SUBJECT: Contract 008066
SR 520, Floating Bridge and Landings Project
Federal Aid No. BR-0520(047)
Change Order No. 190 – South Side Design Settlement

**WASHINGTON STATE
DEPARTMENT OF TRANSPORTATION
CHANGE ORDER**

CONTRACT NO: 008066 FEDERAL AID NO: BR-0520 (047)
CONTRACT TITLE: SR 520 / I-5 TO MEDINA - EVERGREEN POINT FLOATING
CHANGE ORDER NO: 190 SOUTH SIDE DESIGN SETTLEMENT

| PLOTTED BY: Bollen, Brian | DESIGNED BY: B. Bollen 10/12 | CHECKED BY: C. Linden 10/12 | | PROJ. ENGR. 10/12 | REGIONAL ADM. 10/12 | LID WALL EXHIBITS | | |

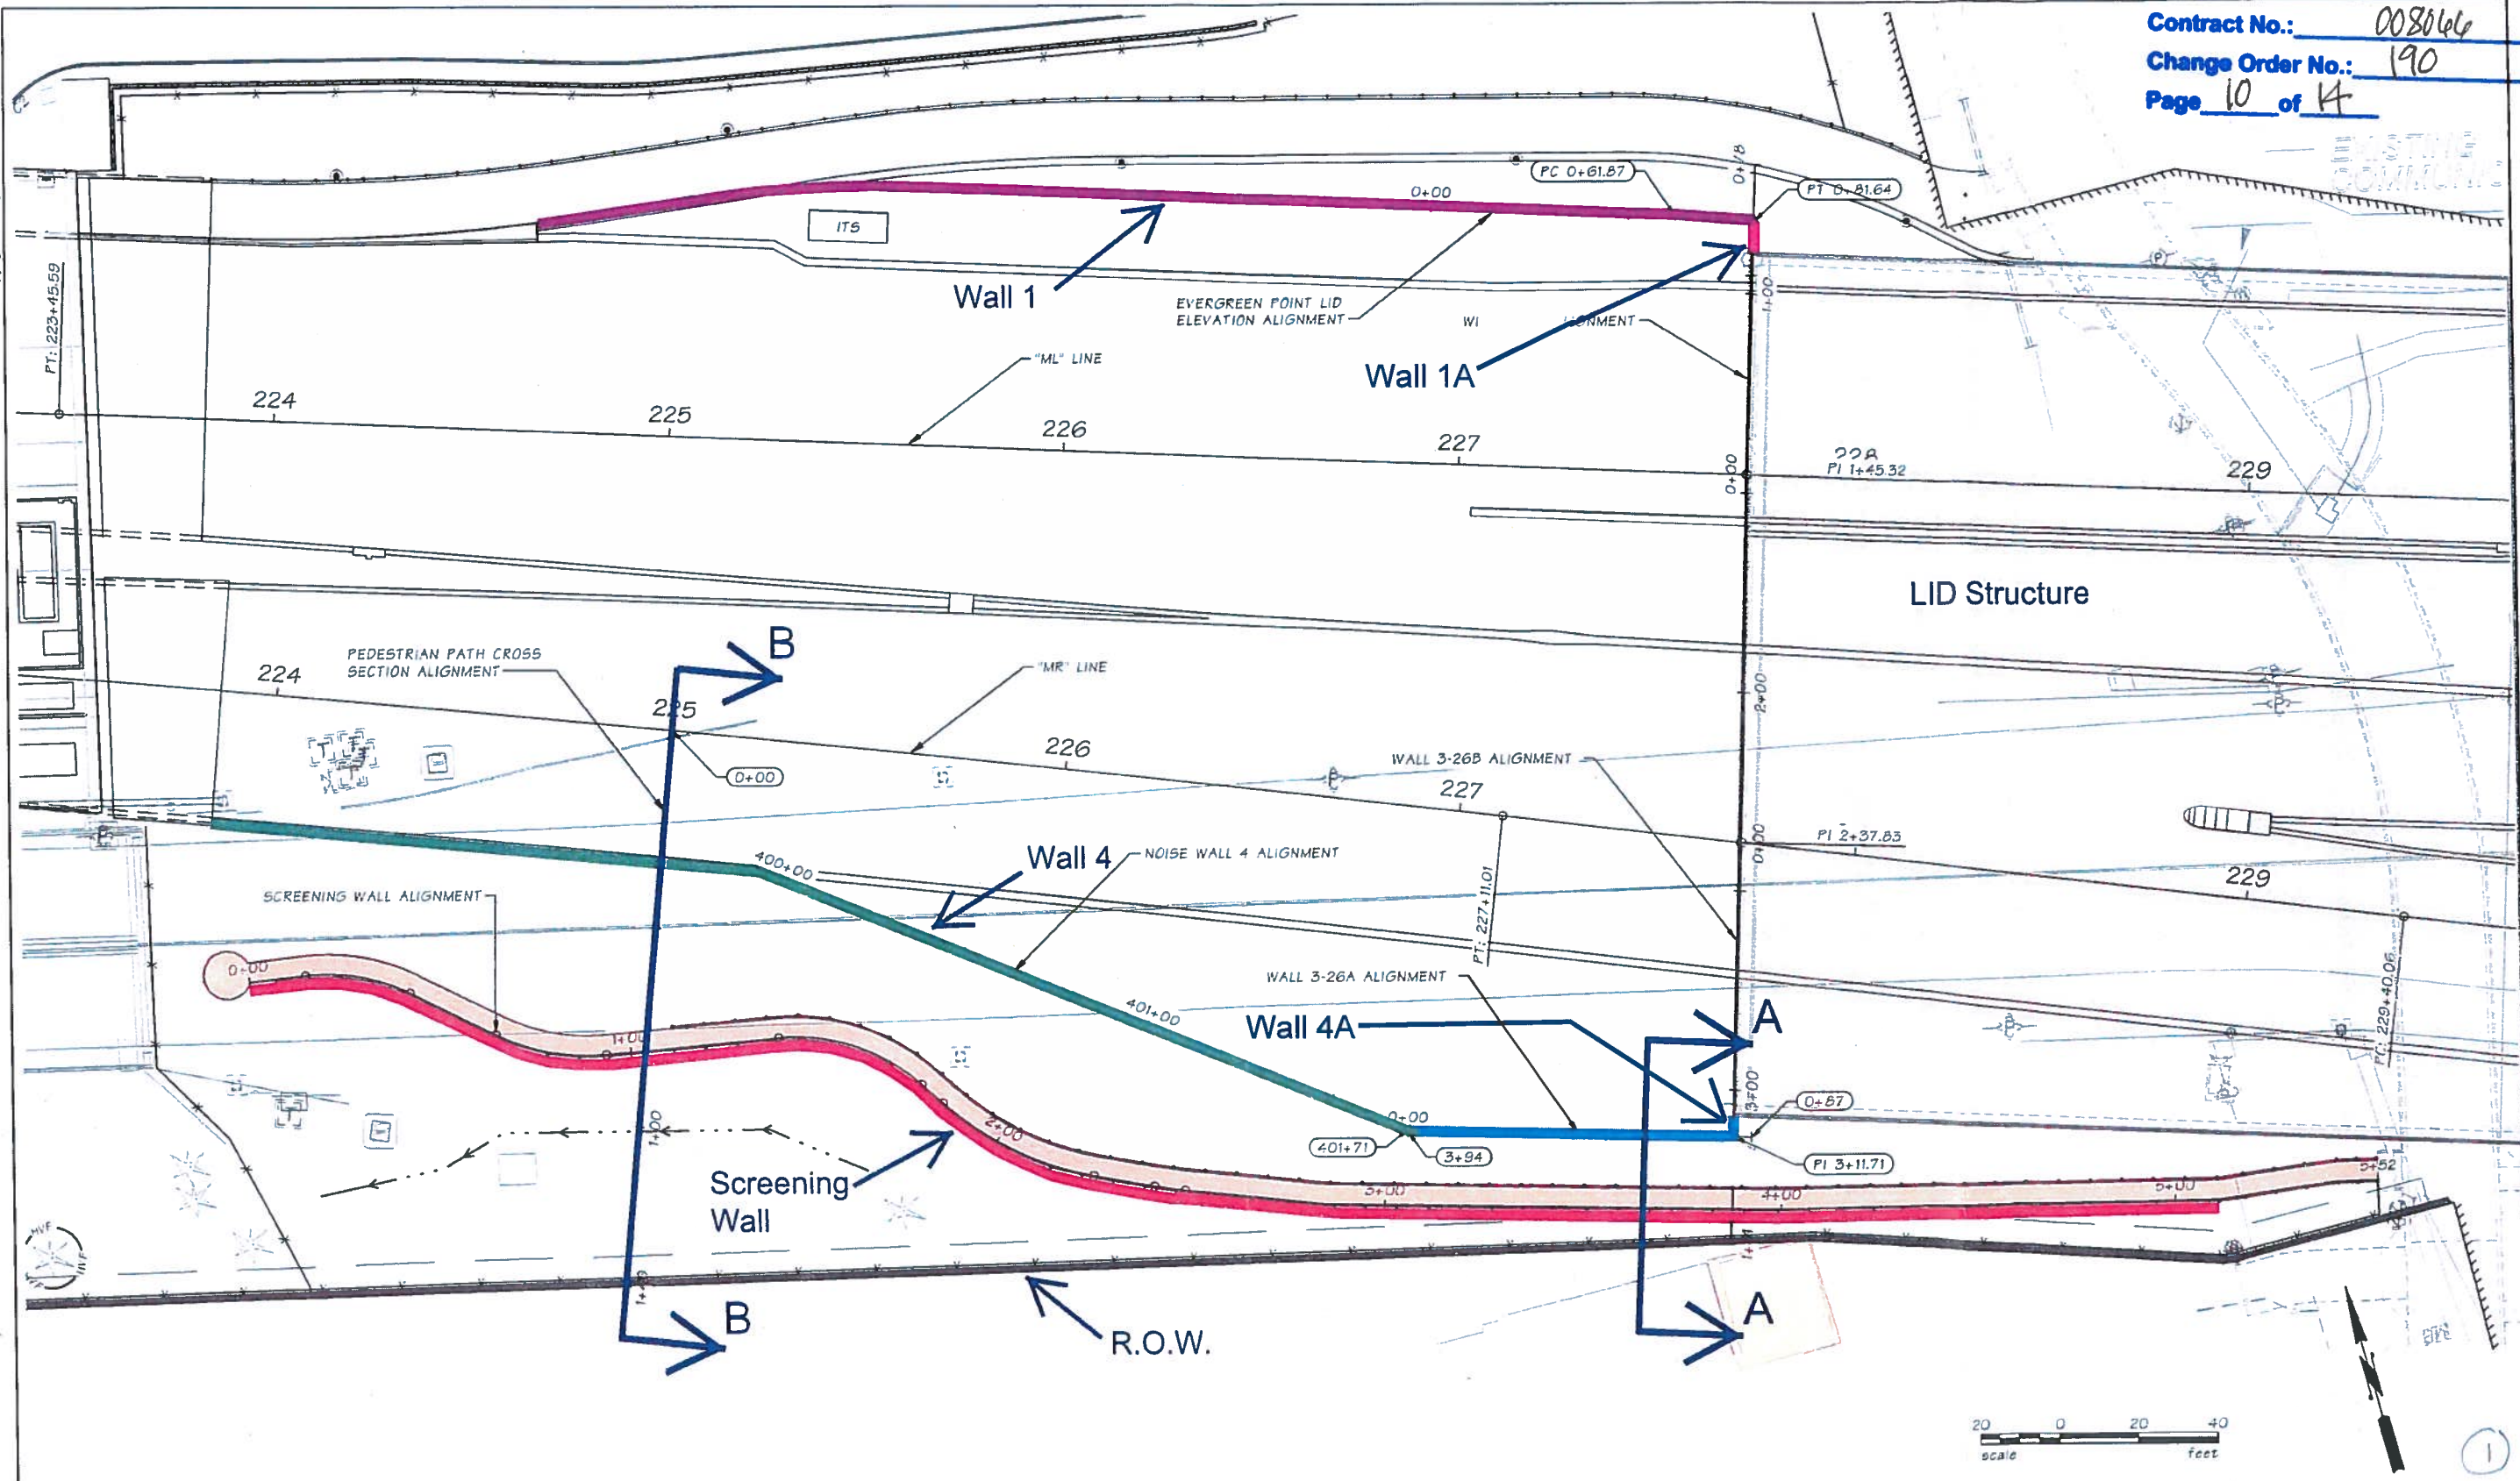
- * Retaining Wall 1A located between Wall 1 and the northwest corner of the Evergreen Point Road lid, and Retaining Wall 4A located between Wall 3-26 and the southwest corner of the Evergreen Point Road lid, as shown on page 10 of 008066 Change Order No. 190.

| FILE NAME | Q:\FederalWay\2012\FAPWT-12-060\CADD\Design\BJB\ECC COORDINATION\Wall 3-26 Exhibit Straight Trail.dwg | | |

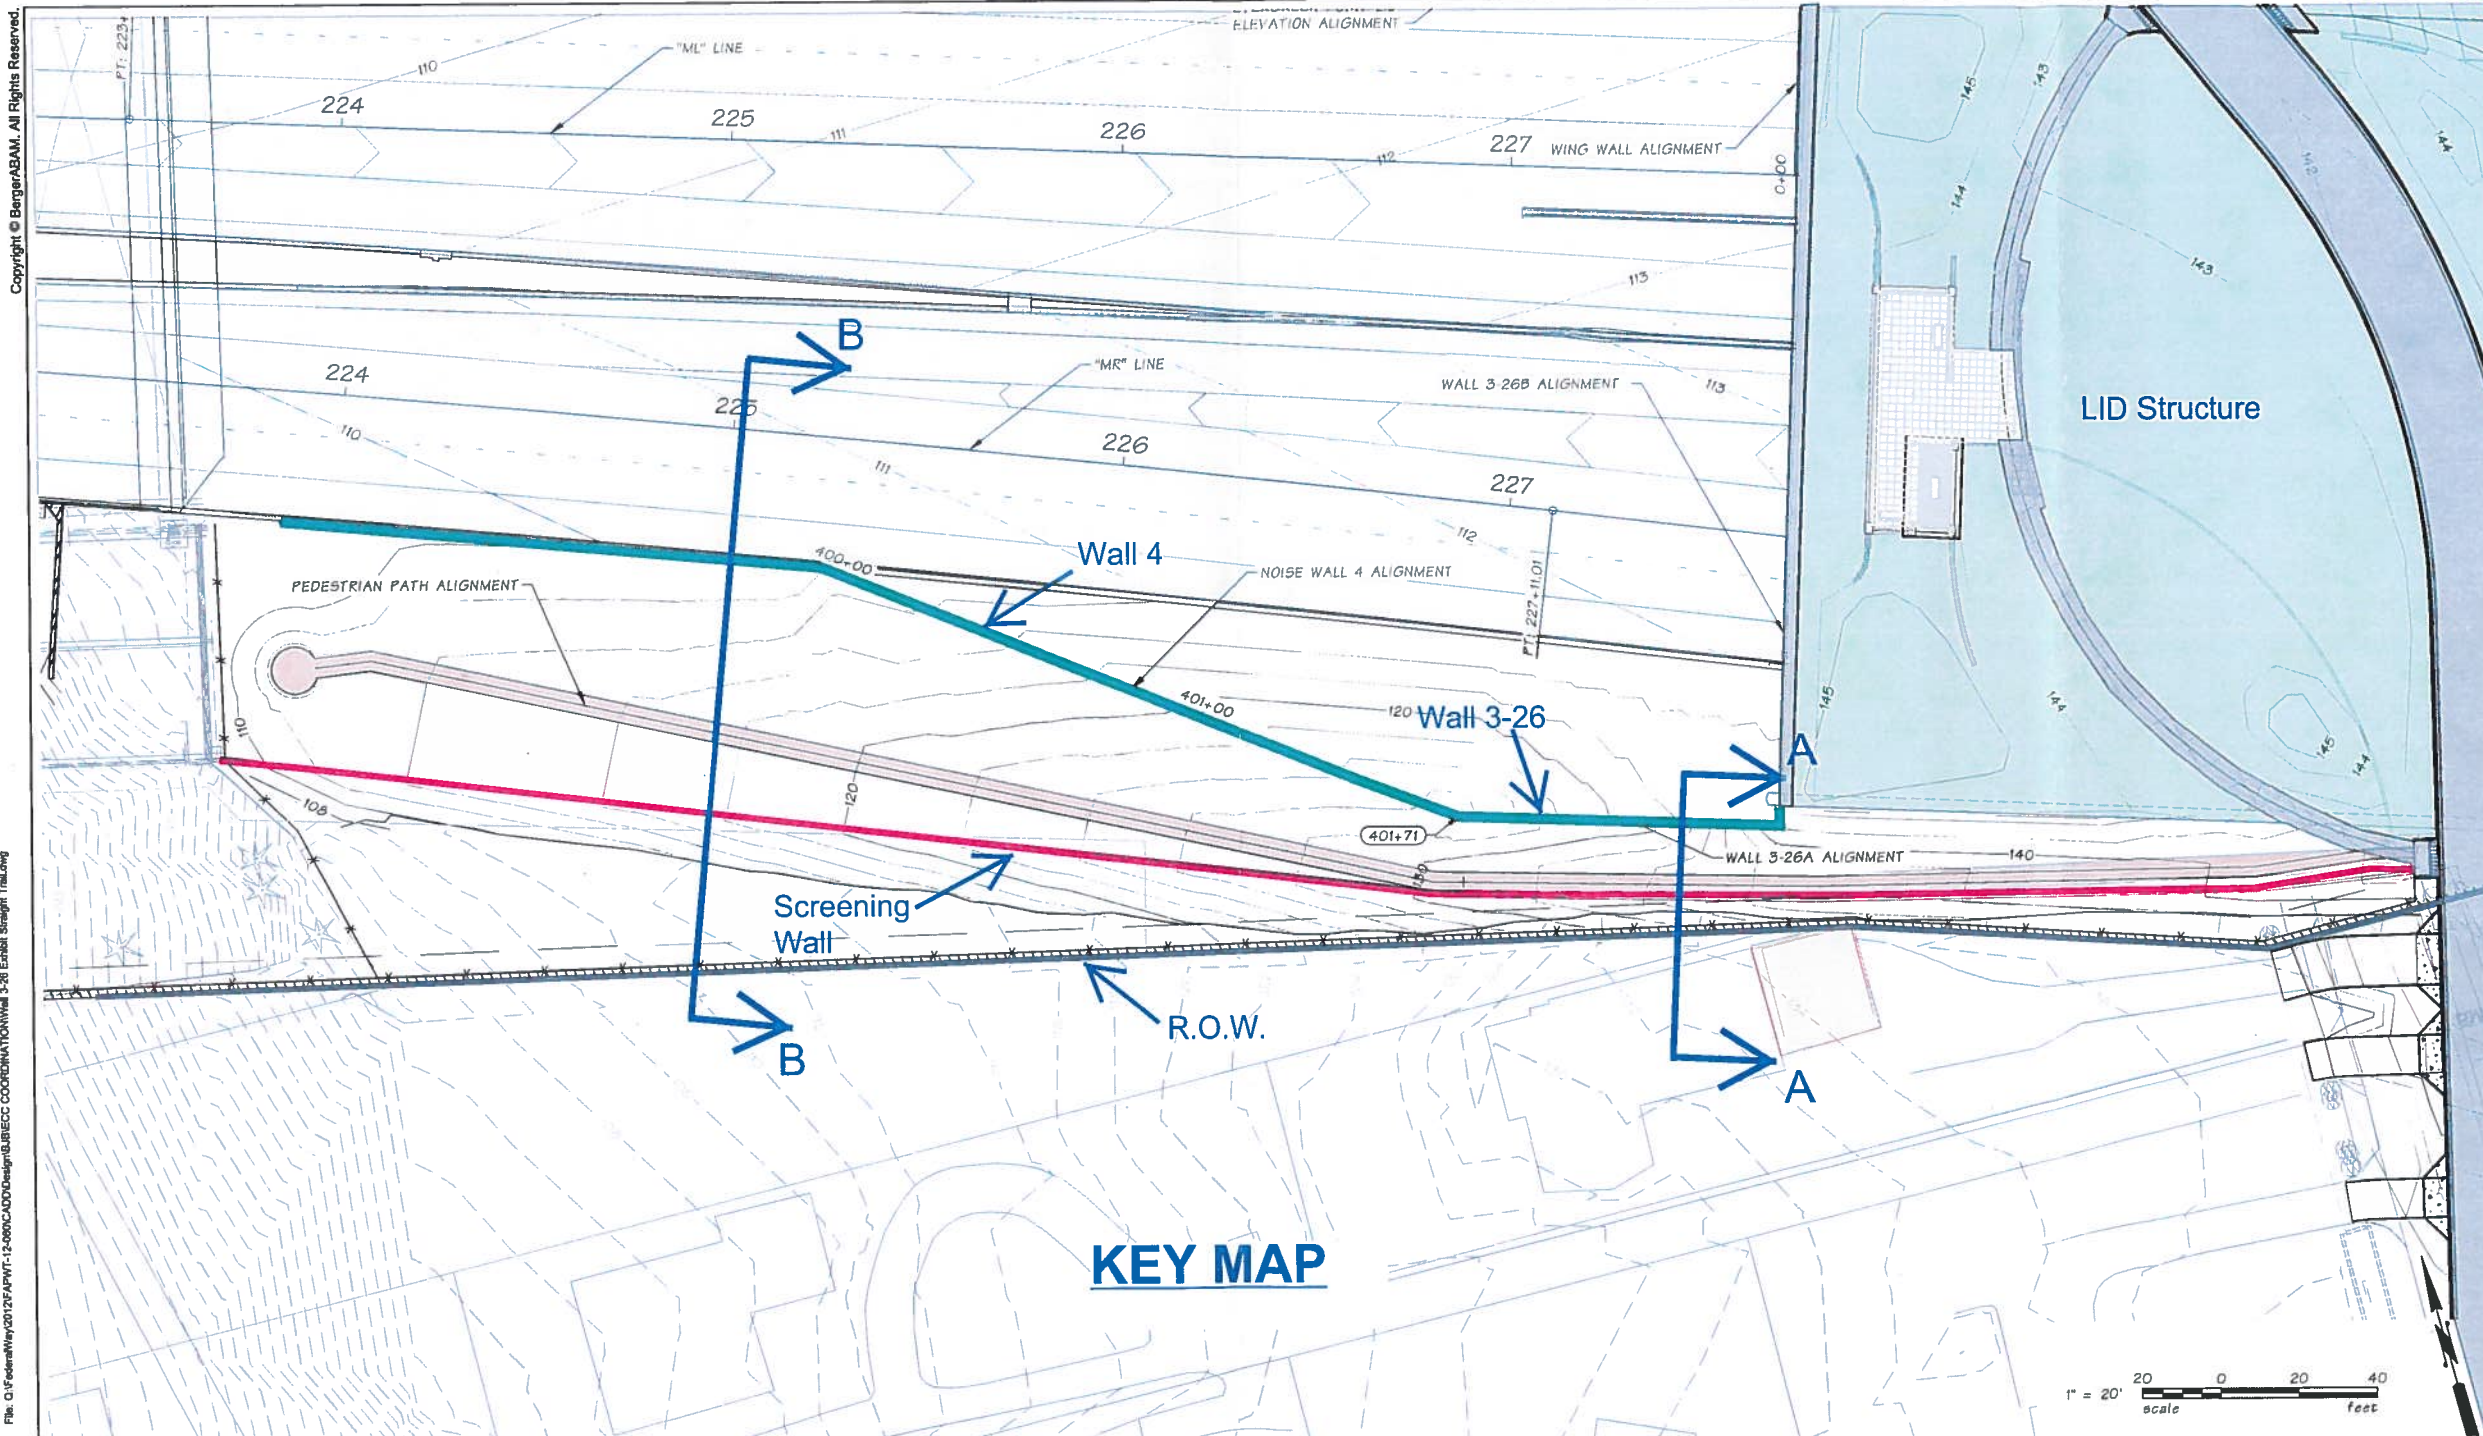
- * Retaining Wall 3-26 located between Wall 4 and Wall 4A as shown on page 11 of 008066 Change Order No. 190.
- * Retaining Wall 4 as shown on page 11 of 008066 Change Order No. 190 to support the Noise Barrier Wall shown in Appendix M1 Conceptual Plans, Bridge Sheet No. WN01 Noise Barrier Wall Layout.

"* Provide the design of a Screening Wall at the location shown on page 11 of 008066 Change Order No. 190. The Screening Wall shall be a minimum of 8-feet high with respect to the finish grade. The Screening Wall shall be constructed using CMU blocks, the surface finish and color of which shall match the CMU blocks used for the exterior of the Bridge Maintenance Facility building; split face finish shall be provided on both sides of the CMU blocks. A stepped profile, in accordance with Section 2.15 and Appendix L1, shall be used in the design and construction of the Screening Wall. The vertical step allowance shall be no greater than 2-foot vertical increments over 48-foot horizontally. Depending upon grade changes, stepping of the wall profile shall maintain the required wall height with modification of distances between steps and/or height of individual steps. Step height shall be consistent with the dimensions of the CMU block used in the Screening Wall. The landscape design of the Screening Wall shall follow the "green over gray" principles specified in Section 2.15, wherever feasible. Provide the necessary earthwork and drainage provisions for the Screening Wall."

SR 520 BRIDGE PEDESTRIAN OVERLOOK

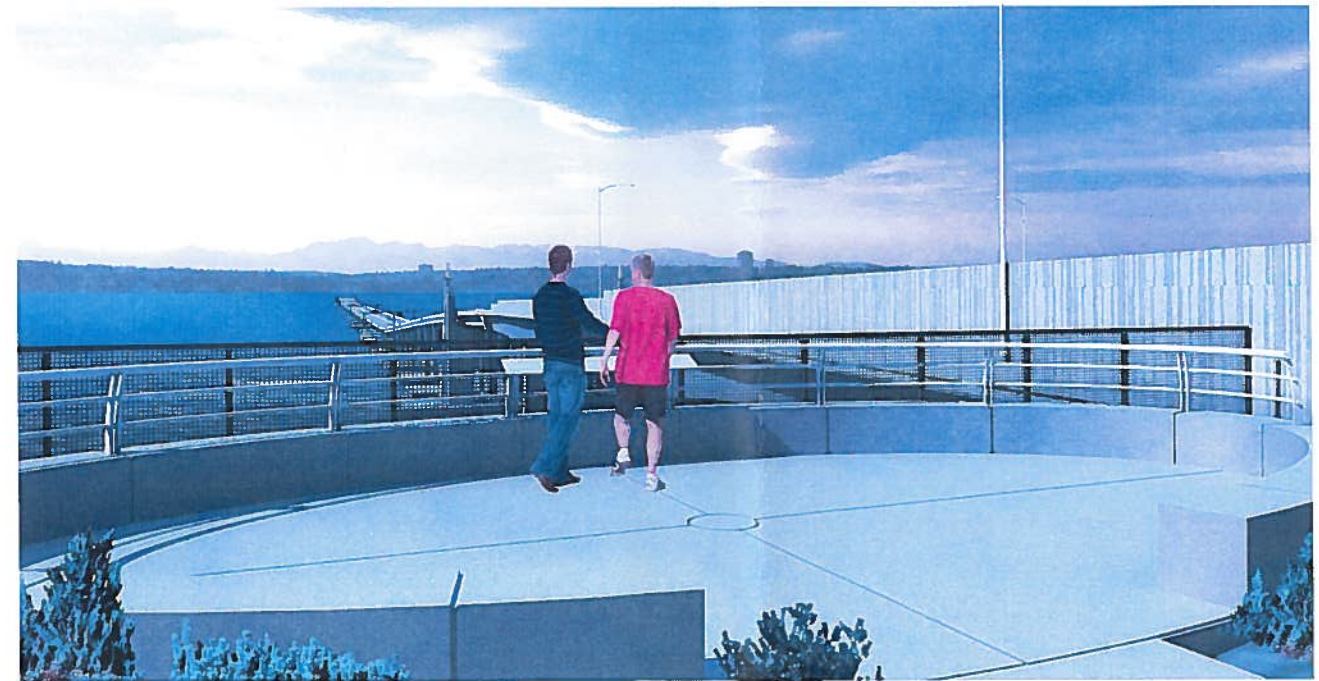
"* The size and configuration of the pedestrian path overlook located at the lower terminus of the pedestrian path shall be as previously coordinated with WSDOT and the City of Medina, and as depicted on pages 12 and 13 of 008066 Change Order No. 190. The pedestrian path overlook shall be furnished with appropriate seating that is coordinated with WSDOT and the City of Medina, and is consistent with requirements in Appendix L1. Coordination will be required with the Eastside Contractor so that there is consistency."
